**LATHROP DITCH IMPROVEMENTS
ITB-25-05**

ADDENDUM NO. 3

March 11, 2025

**Invitation for Bid No.: ITB-25-05
Bid Opening Date and Time: 2:30 P.M., March 18, 2025**

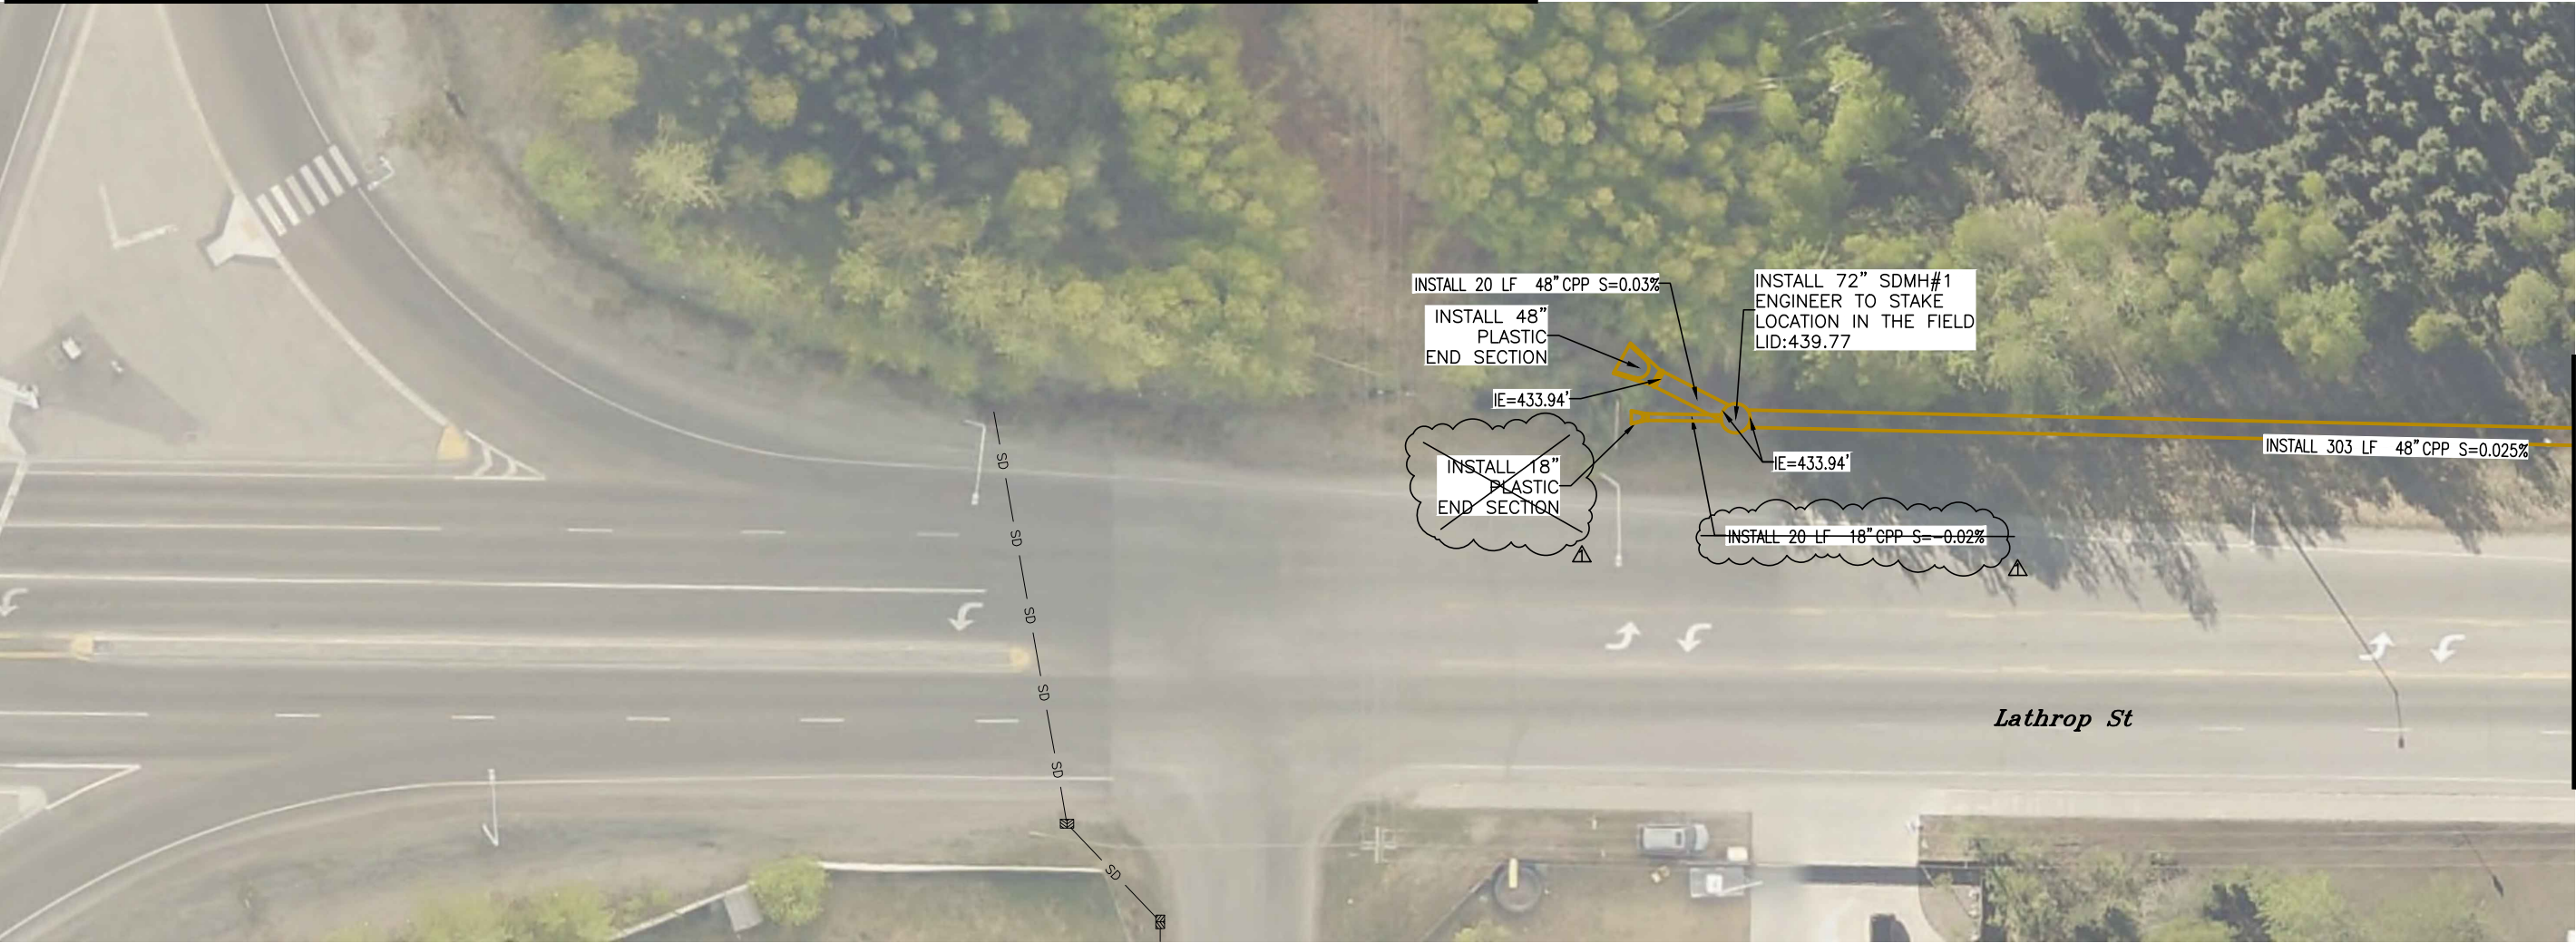
Delete Plan Sheet Nos. A2, U3, U4, and U5 and substitute revised Plan Sheets Nos. A2, U3, U4, and U5.

1. INSTALL NEW 48" CPP STORM DRAIN PIPE IN EXISTING DITCH.
2. ENGINEER WILL PROVIDE TMBs AND STAKE ROW FOR OFFSET TO PIPE AND MANHOLES.
3. CONTRACTOR TO USE LOW PROFILE STORM DRAIN MANHOLE FRAMES (BASIS OF DESIGN: D&L PART # A-2107
4. 48-INCH CPP PIPE OPENINGS IN MANHOLES SHALL BE 1" LARGER THAN THE O.D. OF PIPE.

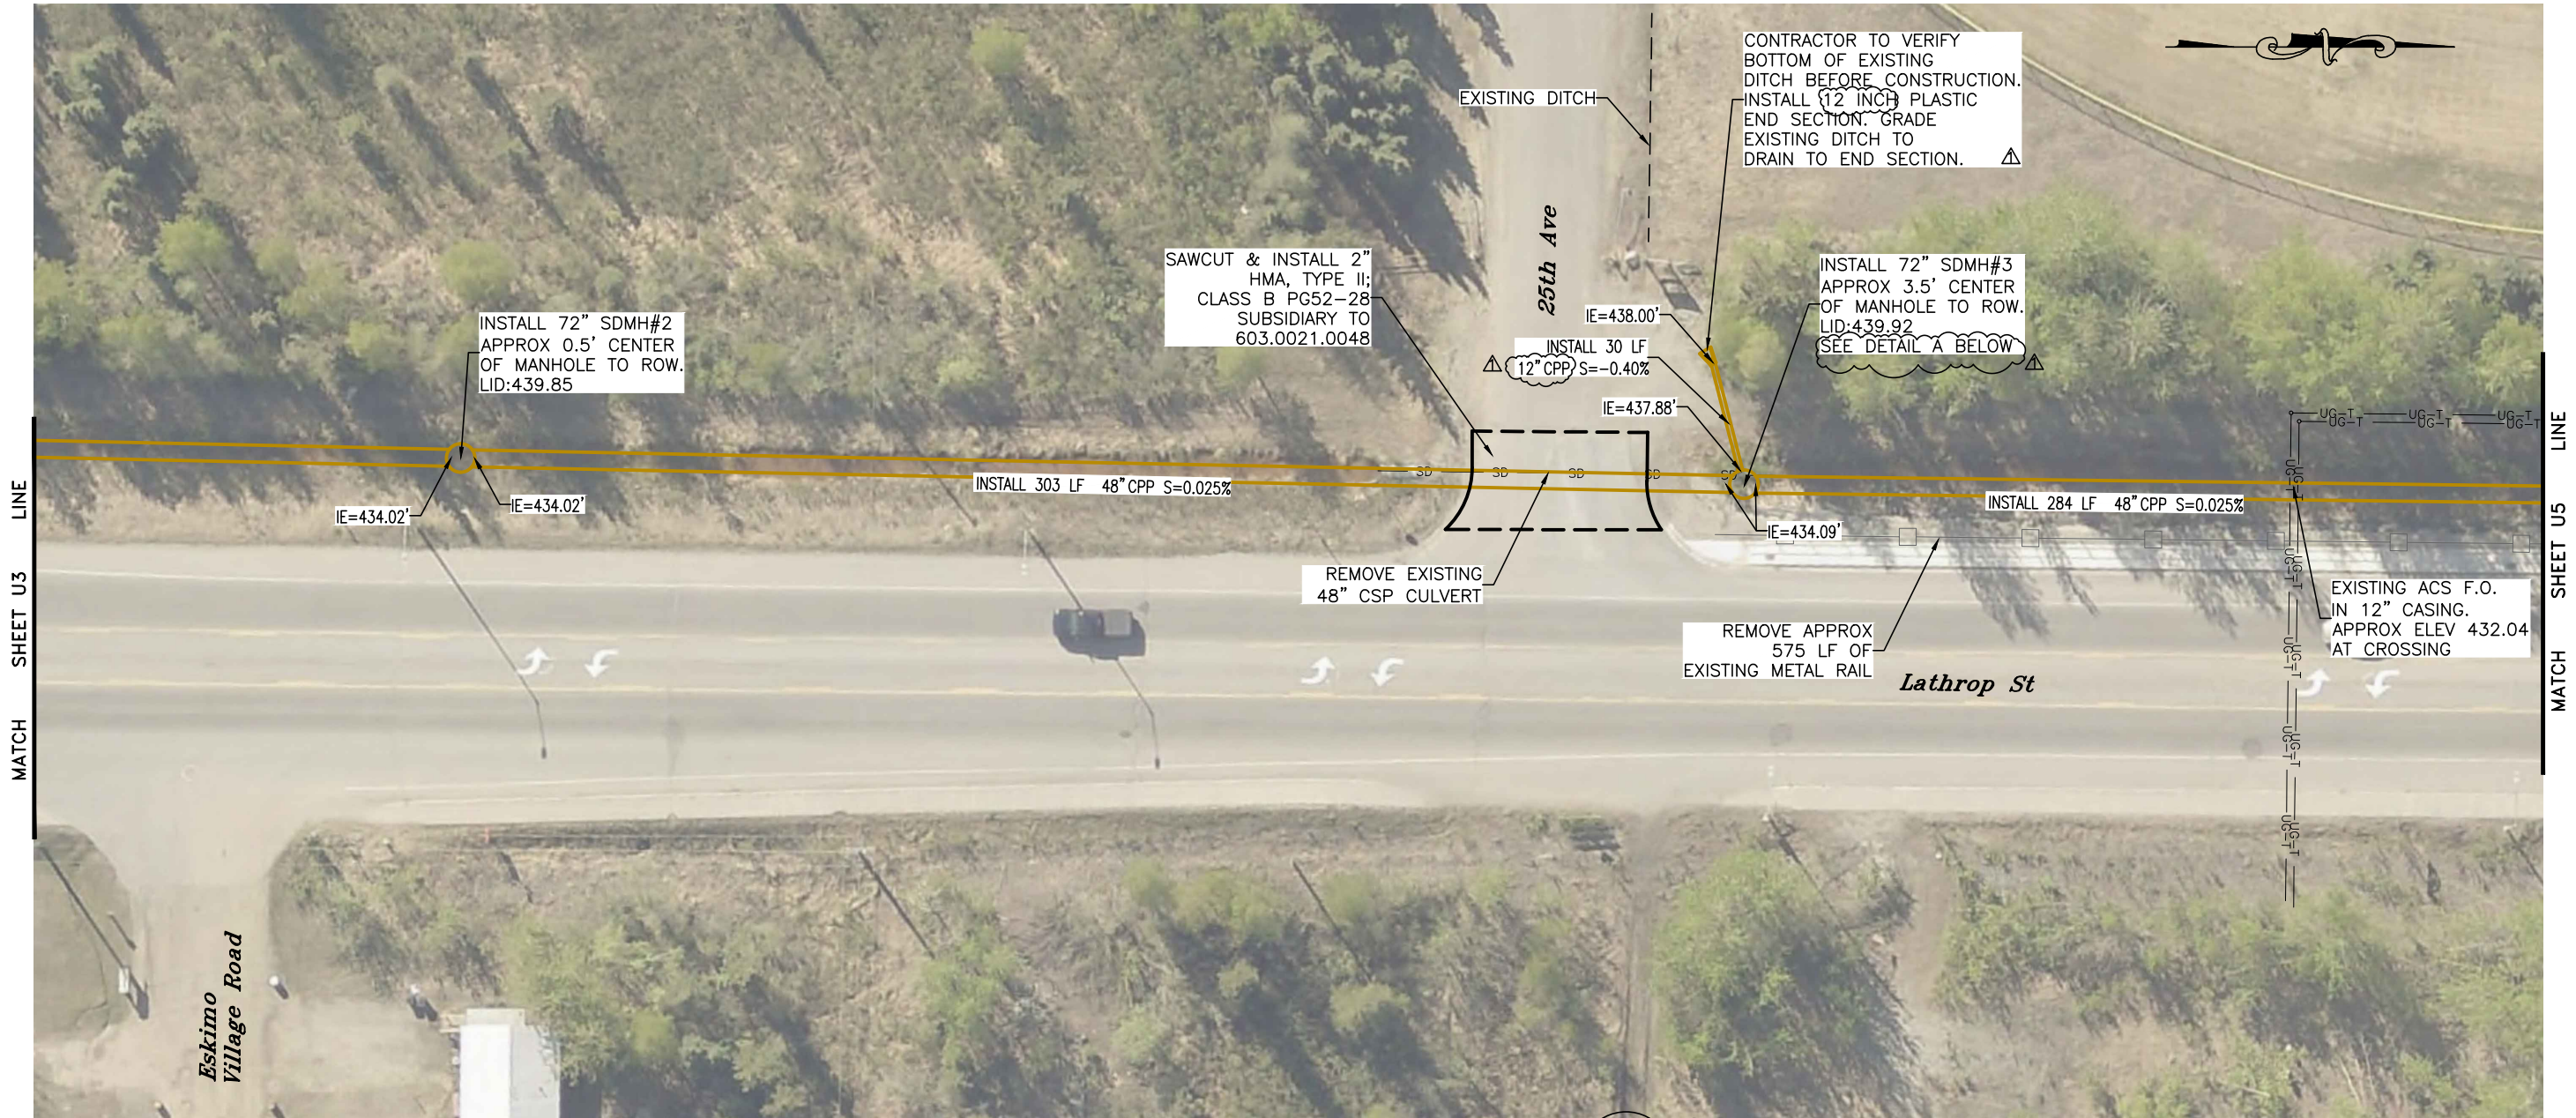
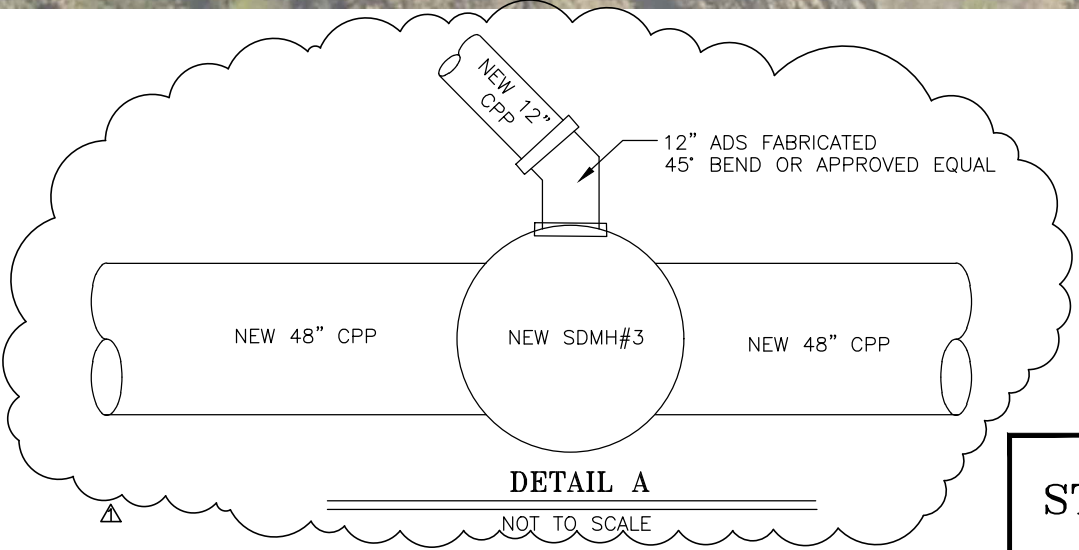
1. INSTALL NEW 48" CPP STORM DRAIN PIPE IN EXISTING DITCH.
2. ENGINEER WILL PROVIDE TMBs AND STAKE ROW FOR OFFSET TO PIPE AND MANHOLES.
3. CONTRACTOR TO USE LOW PROFILE STORM DRAIN MANHOLE FRAMES (BASIS OF DESIGN: D&L PART # A-2107
4. 48-INCH CPP PIPE OPENINGS IN MANHOLES SHALL BE 1" LARGER THAN THE O.D. OF PIPE.

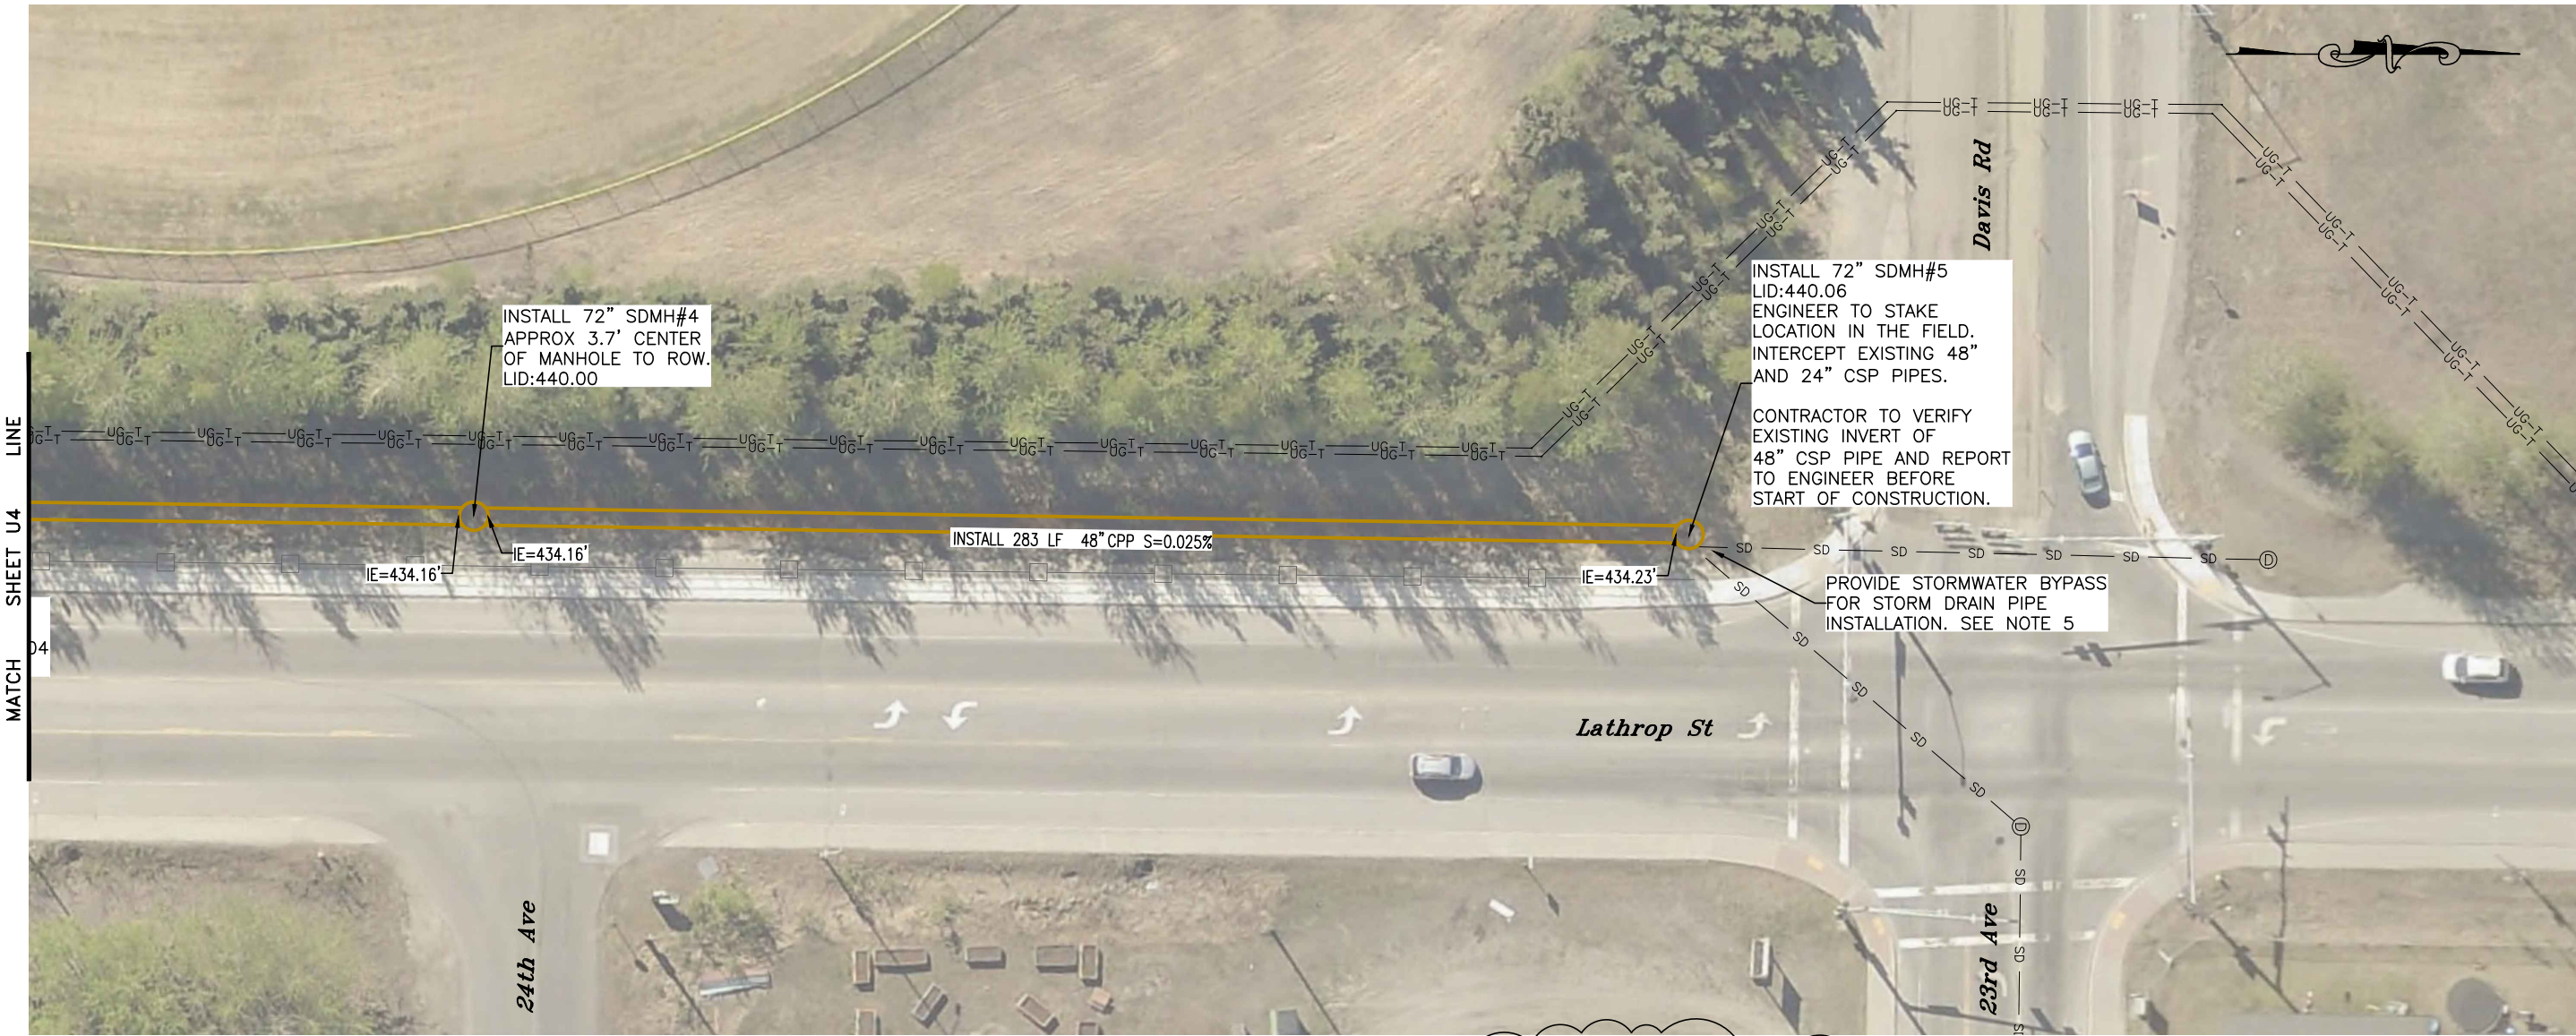
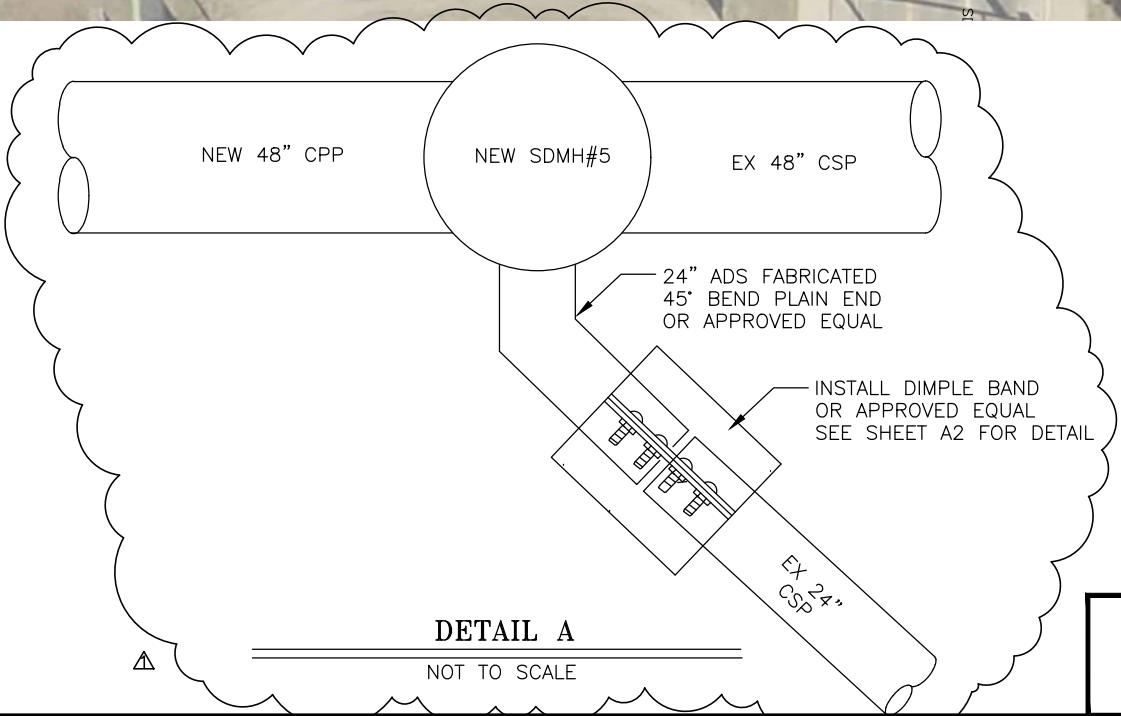
1. CONTRACTOR TO VERIFY EXISTING DITCH ELEVATION AS SHOWN ON SHEET U1 AND EXISTING 48" CSP INVERT AS SHOWN ON SHEET U5 AND REPORT TO ENGINEER BEFORE INSTALLATION OF NEW 48-INCH CPP STORM DRAIN PIPE.
2. INSTALL NEW 48" CPP STORM DRAIN PIPE IN EXISTING DITCH.
3. ENGINEER WILL PROVIDE TMBs AND STAKE ROW FOR OFFSET TO PIPE AND MANHOLES.
4. CONTRACTOR TO USE LOW PROFILE STORM DRAIN MANHOLE FRAMES (BASIS OF DESIGN: D&L PART #A-2107).
5. CONTRACTOR TO PROVIDE STORMWATER BYPASS DURING STORM DRAIN INSTALLATION. ESTIMATED FLOW 561 GPM (MEASURED ON 2/14/2025) AND 552 GPM (MEASURED ON 2/18/2025). THIS WORK IS SUBSIDIARY TO PAY ITEM 603.0021.0048.
5. 48-INCH CPP PIPE OPENINGS IN MANHOLES SHALL BE 1" LARGER THAN THE O.D. OF PIPE.

STORM DRAIN MANHOLE DETAILS SUPPLEMENTAL DETAIL

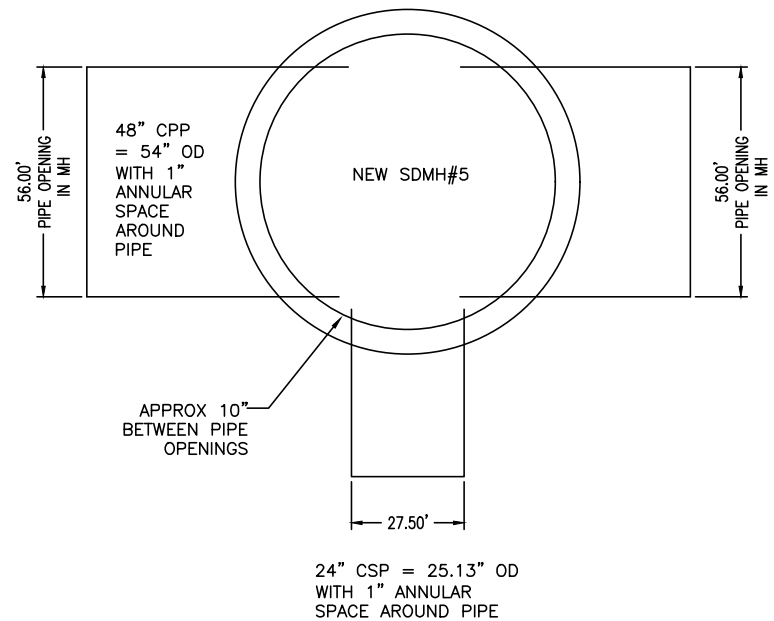
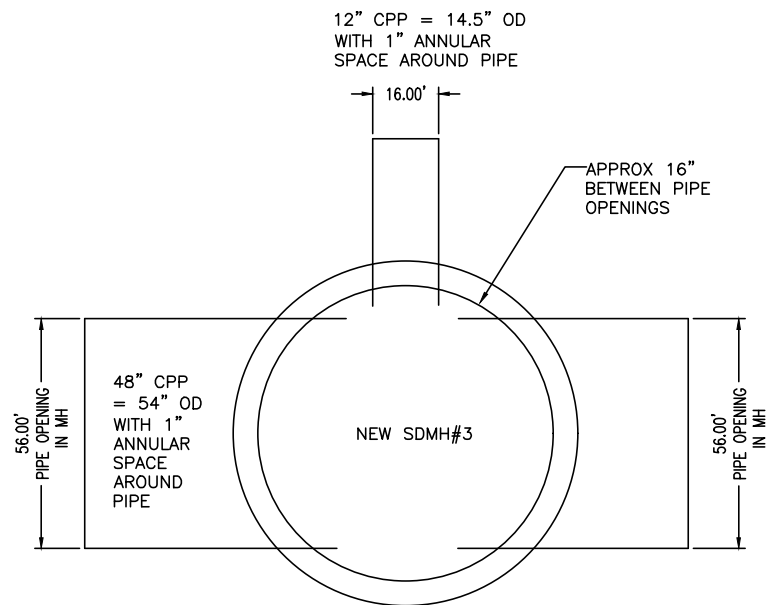
Add new Supplemental Detail – Storm Drain Manhole Detail
